NOVA SCOTIA ENERGY BOARD

IN THE MATTER OF: AN APPEAL by NOVA SCOTIA POWER INCORPORATED DRO
Appeal - Transformer Safety Issues -S L Doward

INFORMATION REQUESTS

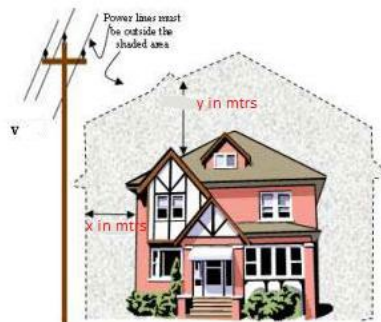
Board staff understand that two stakes have been positioned where the proposed stub pole and the buried anchor for the overhead guy wire will be installed in the Halifax Regional Municipality (HRM) right-of-way. However, Board staff also understand that, depending on the voltage of the power line, regulations provide x and y value in meters, and the power lines must be outside the shaded region as shown in the image below:

a) Does NS Power concur with Board staff's understanding as expressed in the above preamble?

A. Please provide the values of x and y, along with the standards used as reference.

1 B. Please provide the measurements of x and y for the residence, assuming
2 that the wall of the house is considered part of the building's
3 protuberances.

5 A. Please provide the values of x and y, along with the standards used as
6 reference.

7 B. Please provide an envelope drawing that includes the building in relation
8 to the proposed installed pole, illustrating how the x and y measurements
9 will be taken.

10 C. Please provide the measurements of x and y for the residence, assuming
11 that the wall of the house is considered part of the building's
12 protuberances.
